YAMAHA SERVICE NEWS

Service News 195

YL2C - STARTER DYNAMO

ARMATURE ASSEMBLY

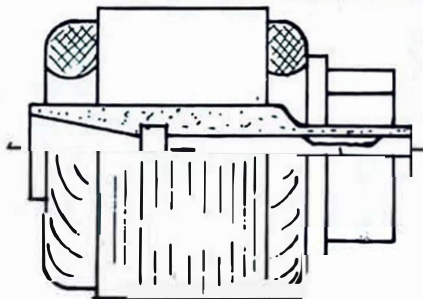
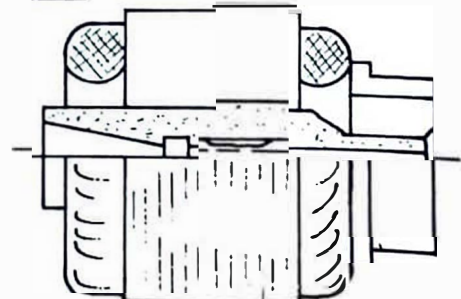
Armature assembly screw hole has been changed from 8mm to 10mm thread.

OLD TYPE M8 P1.25
Part No. 165-81155-20

NEW TYPE M10 P1.25
Part No. 165-81155-21

** Service Note: Interchangeable as a set only.
